Dresden Nuclear Power Station, Units 2 and 3
Facility Operating License Nos. DPR-19 and DPR-25
NRC Docket Nos. 50-237 and 50-249

LaSalle County Station, Units 1 and 2
Facility Operating License Nos. NPF-11 and NPF-18
NRC Docket Nos. 50-373 and 50-374

Quad Cities Nuclear Power Station, Units 1 and 2
Facility Operating License Nos. DPR-29 and DPR-30
NRC Docket Nos. 50-254 and 50-265

Subject: Revision A to Request for Technical Specifications Changes for Dresden Nuclear Power Station, Units 2 and 3, LaSalle County Station, Units 1 and 2, and Quad Cities Nuclear Power Station, Units 1 and 2, to Implement Improved Standard Technical Specifications

Reactor Vessel Water Level -High

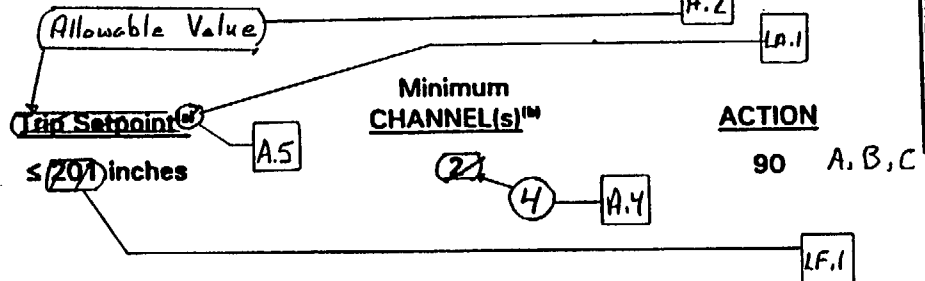
- A.5 The Trip Setpoint for Reactor Vessel Water Level - High, in Table 3.2.J-1 is referenced to the top of active fuel. The reference value for the Allowable Value specified in ITS SR 3.3.2.2.4 is associated with "instrument zero." This change has been made for human factors considerations. The indications in the control room can be directly associated with the value in the ITS. Any change to the Trip Setpoint is addressed in Discussion of Changes A.2 and LF.1, therefore this change is considered administrative.

- LA.1 The detail in CTS Table 3.2.J-1 Note (a) related to the reference setting of the reactor vessel water level instrumentation is proposed to be relocated to the UFSAR. The reference value for the Allowable Value specified in ITS SR 3.3.2.2.4 is associated with "instrument zero," as discussed in Discussion of Change A.5. This detail is not necessary to ensure the OPERABILITY of the Feedwater System and Main Turbine High Water Level Instrumentation. The requirements of ITS 3.3.2.2 and its associated SRs are adequate to ensure the associated reactor vessel water level instrumentation is maintained OPERABLE. Therefore, the relocated detail is not required to be in the ITS to provide adequate protection of the public health and safety. Changes to the UFSAR will be controlled by the provisions of 10 CFR 50.59.

Functional Unit
LCO 3.3.4.1.a 1. Reactor Vessel Water Level - Low Low
LCO 3.3.4.1.b 2. Reactor Vessel Pressure - High

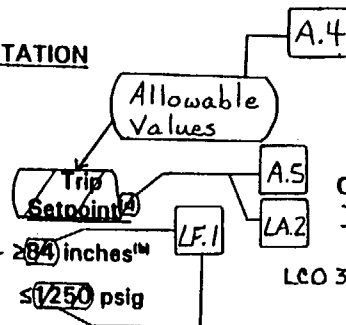
- A.5 The Trip Setpoint for Functional Unit 1, Reactor Vessel Water Level - Low Low, in Table 3.2.C-1 is referenced to the top of active fuel. The reference value for the Allowable Value specified in ITS SR 3.3.4.1.4.a is associated with "instrument zero." This change has been made for human factors considerations. The indications in the control room can be directly associated with the value in the ITS. Any change to the Trip Setpoint is addressed in Discussion of Changes A.4 and LF.1, therefore this change is considered administrative.

- LA.2 The detail in CTS Table 3.2.C-1 Note (c) related to the reference setting of the
reactor vessel water level instrumentation is proposed to be relocated to the
UFSAR. The reference value for the Allowable Value specified in ITS SR

3.3.4.1.4.a has been changed to the value associated with "instrument zero," as
discussed in Discussion of Change A.5. This detail is not necessary to ensure
the OPERABILITY of the ATWS-RPT instrumentation. The requirements of
ITS 3.3.4.1 and the Surveillances are adequate to ensure the ATWS-RPT reactor
vessel water level instrumentation is maintained OPERABLE. Therefore, this
relocated detail is not required to be in the ITS to provide adequate protection of
public health and safety. Changes to the UFSAR will be controlled by the
provisions of 10 CFR 50.59.

Table 3.3.6.1-1
TABLE 3.2.A-1 (Continued)

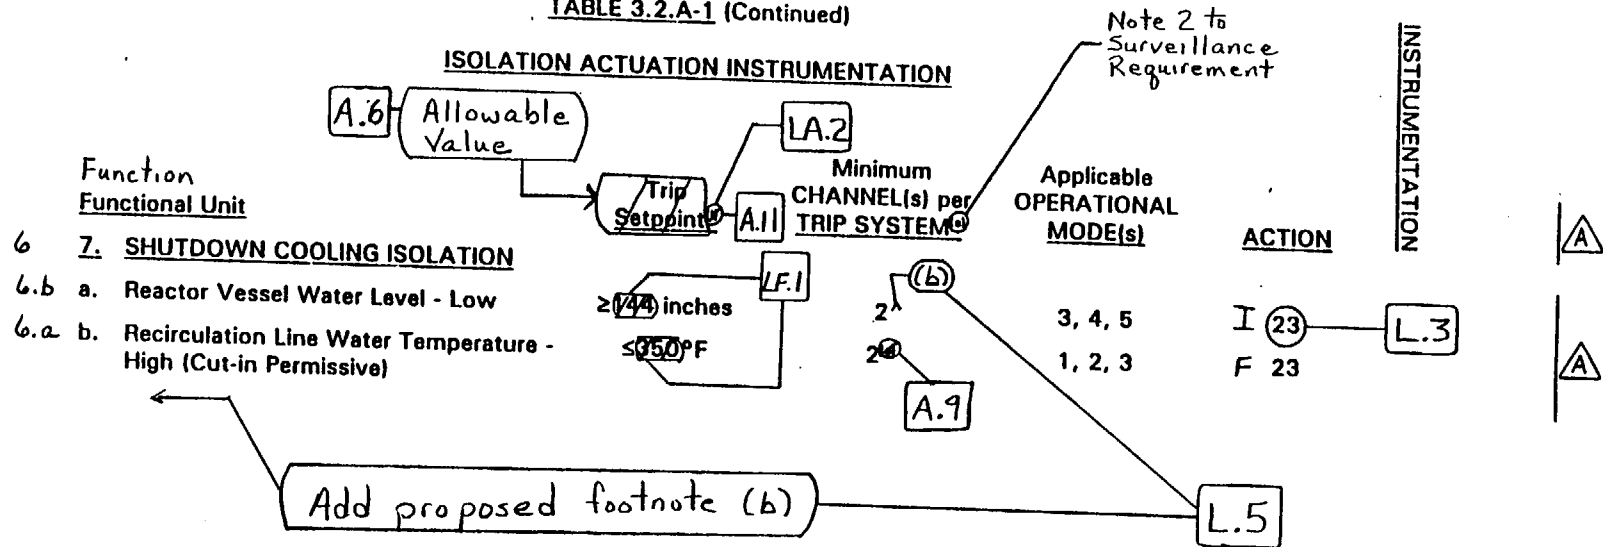
- A.10 CTS 3.2.A and CTS Table 3.2.A-1 require Functional Unit 3.e, Main Steam Line (MSL) Tunnel Temperature—High, to have at least 2 channels (of the 4) in each of 2 sets OPERABLE per trip system. It is proposed to clarify this requirement by replacing the words "2 of 4 in each of 2 sets" with "2 per trip string" such that the requirement is consistent with the terminology used in BWR ISTS, NUREG-1433, Rev. 1, for describing other similar trip logic schemes. The MSL Tunnel Temperature—High Functional Unit includes a total of 16 temperature switches, four for each steam tunnel area. One channel from each steam tunnel area inputs to one of four trip strings. Two trip strings make up a trip system and both trip systems must trip to cause an isolation. According to the CTS terminology, a "set" refers to the four area temperature switches that are arranged in a series contact scheme. Each "set" of four temperature switch contacts open on high temperature to actuate (de-energize) a logic relay. The BWR ISTS would refer to this trip logic scheme as a "trip string." Thus, the CTS terminology for a "set" is equivalent to the BWR ISTS terminology for a "trip string." Furthermore, since there are two trip strings per trip system, the minimum channel requirement of "2 of 4 in each of 2 sets" is equivalent to the proposed requirement of "2 per trip string." This change is considered a presentation preference change since it serves only to clarify an existing requirement by using the BWR ISTS terminology. As such, this change is administrative.

- M.1 An additional Function has been added, ITS Table 3.3.6.1-1 Function 1.c. This Function is the Main Steam Line Low Pressure—Timer (or Time Delay). This Function is required to ensure the OPERABILITY of the current and proposed MSL Pressure—High Function (CTS Table 3.2.A-1 Function 3.c and ITS Table 3.3.6.1-1 Function 1.b). This Function provides a time delay for the MSL Pressure—High Function to ensure an inadvertent main steam line isolation does not occur during transients which result in reactor steam dome pressure perturbations. However, the delay is limited to ensure proper operation during pressure regulator failure event. Appropriate ACTIONS and Surveillance Requirements have also been added. This change is an additional restriction on plant operation necessary to ensure the design basis accident analysis assumptions are satisfied.

- M.2 The minimum required channels for the Standby Liquid Control System Initiation Function in CTS Table 3.2.A-1 (Functional Unit 4.a) is NA. For the same Function in the ITS (ITS Table 3.3.6.1-1 Function 5.a) the required channels per trip system is specified to be 1. The switch provides trip signal inputs to one trip system in any position other than "OFF." For this Specification, the SLC initiation switch is considered to provide 1 channel input into the trip system. Since the requirement is more explicit, this change is considered more restrictive on plant operations.

Table 3.3.1.1-1 (page 2 of 3)
Reactor Protection System Instrumentation

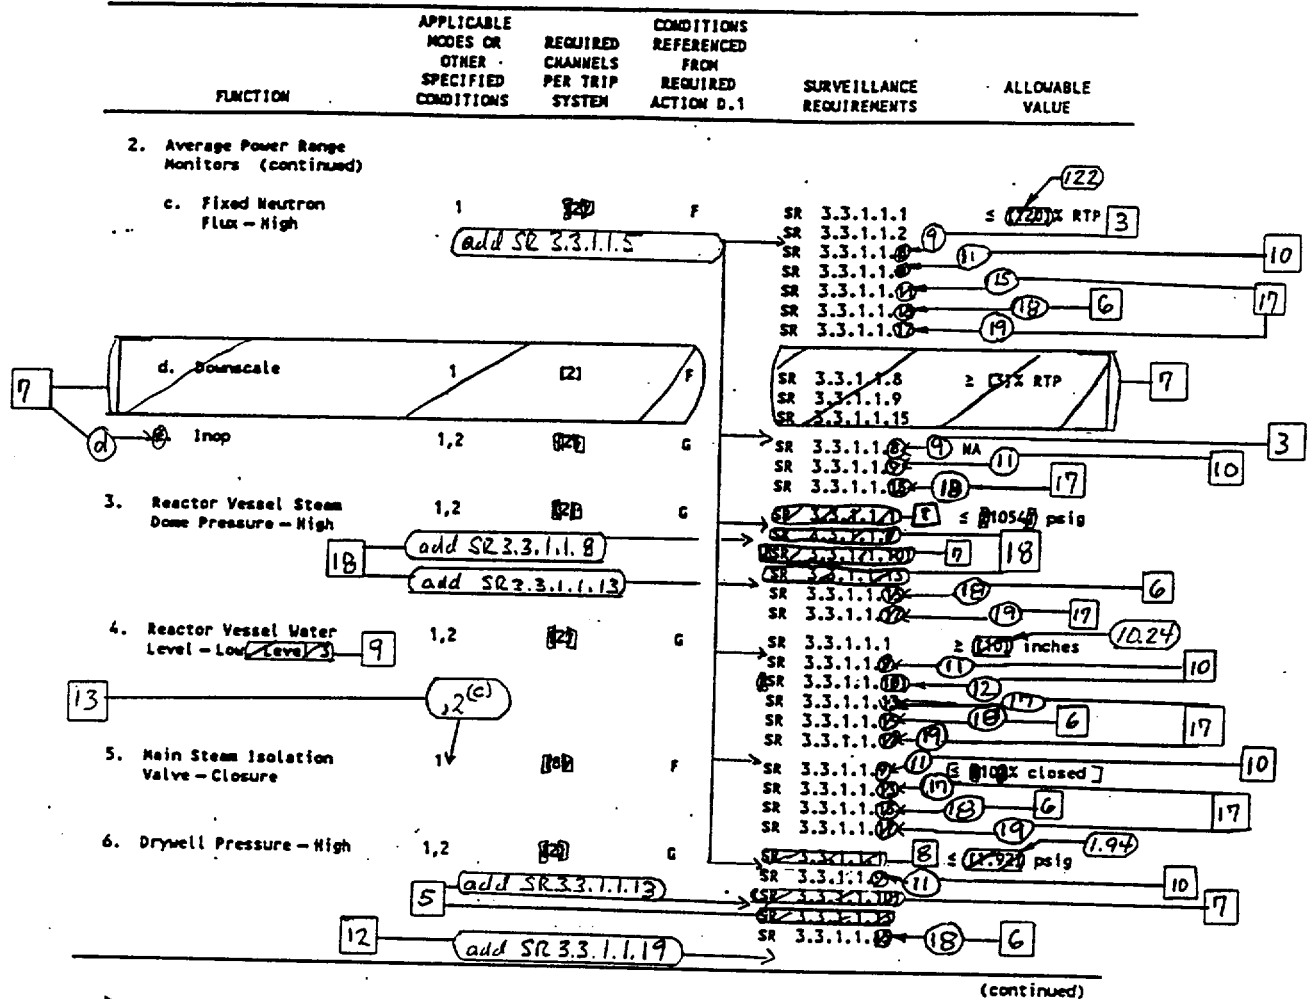
- A.15 The Trip Setpoint for Functional Unit 4, Reactor Vessel Water Level – Low, in Table 2.2.A-1 is referenced to the top of active fuel. The reference value for the Allowable Value specified in ITS Table 3.3.1.1-1 for Function 4 is associated with "instrument zero." This change has been made for human factors

- A.15 (cont'd) considerations. The indications in the control room can be directly associated with the value in the ITS. Any change to the Trip Setpoint is addressed in Discussion of Changes A.10 and LF.1, therefore this change is considered administrative.
